DRAWN BY: BMA
 DESIGN BY: CBL
 ORIG. ISSUE DATE: 06/13/2017

EROSION CONTROL PLAN
 C400

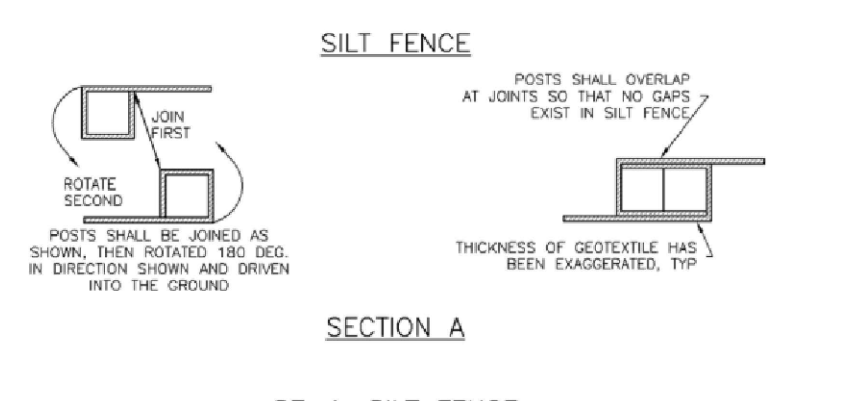
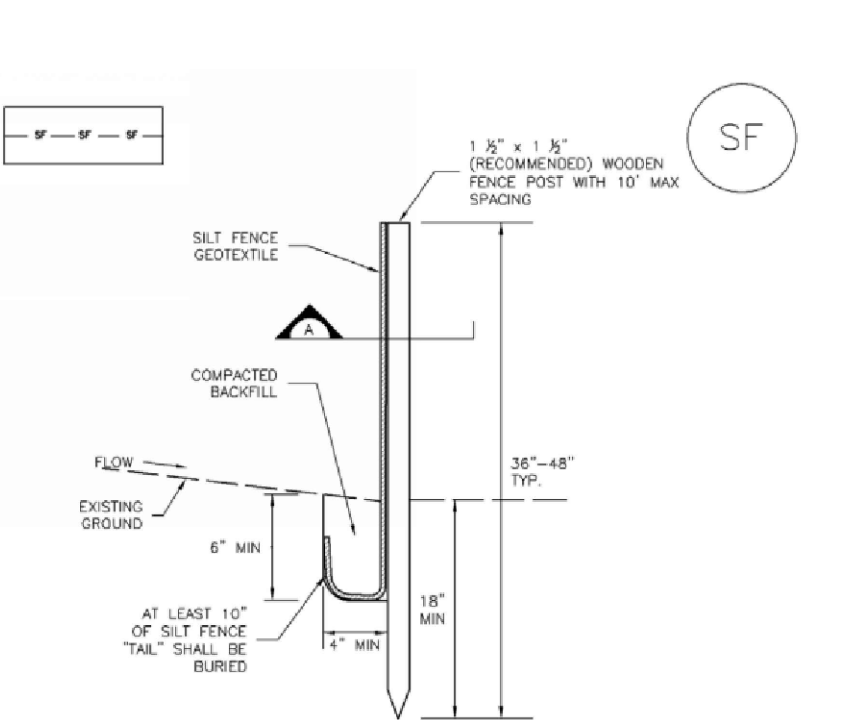
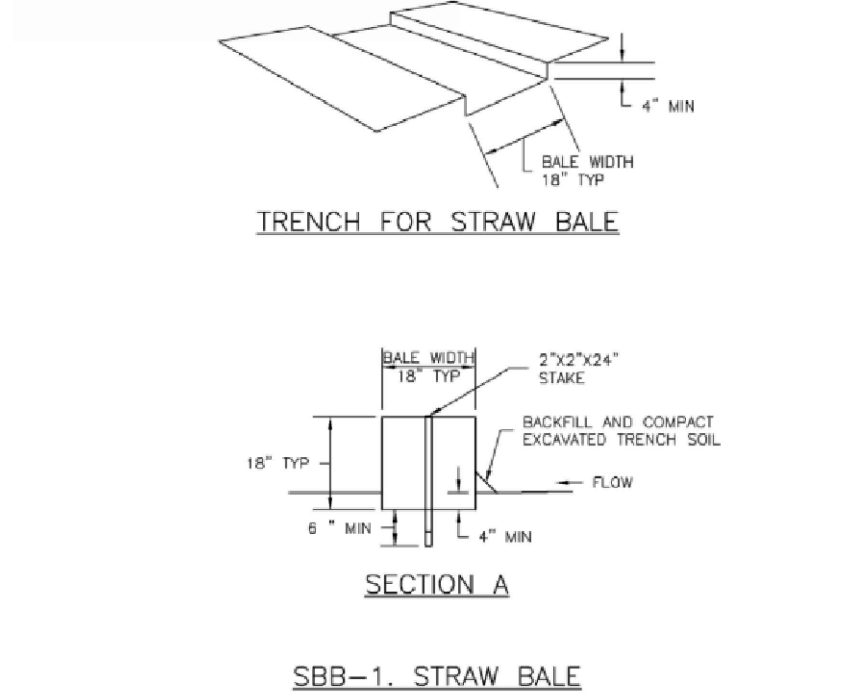
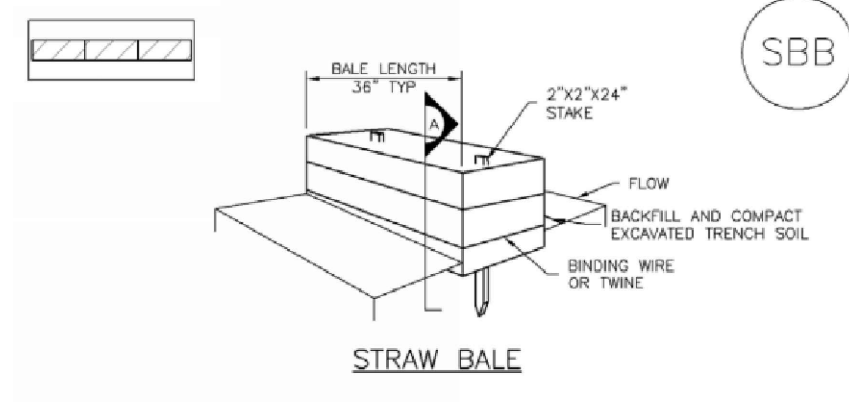
Subject: Cloud+
Page Label: [7] COS C400 SWPPP
Lock: Unlocked
Status:
Checkmark: Unchecked
Author: dsdrice
Date: 8/30/2017 11:45:29 AM
Color: ■

EPC requires 75'
